REMARKS

VERSION WITH MARKINGS TO SHOW CHANGES MADE

FIG. 1

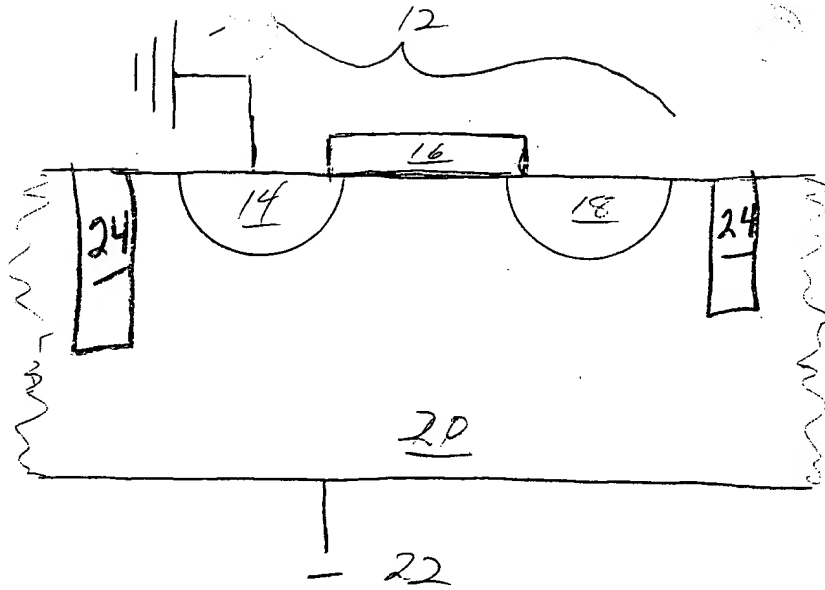
The drawings were objected to under 37 C.F.R. § 1.83(a). Although the "field oxide region" was described in the specification at page 7, line 21 to page 8, line 2, it was not shown in Fig. 1. Attached hereto is new Fig. 1 showing the field oxide region 24 surrounding the FET to correct the informality. Page 5, second complete paragraph has been amended to add the reference number "24." Support can be found at page 7, line 21 to page 8, line 2, i.e., LOCOS. No new matter is being added.

New Fig. 1 has been attached hereto.
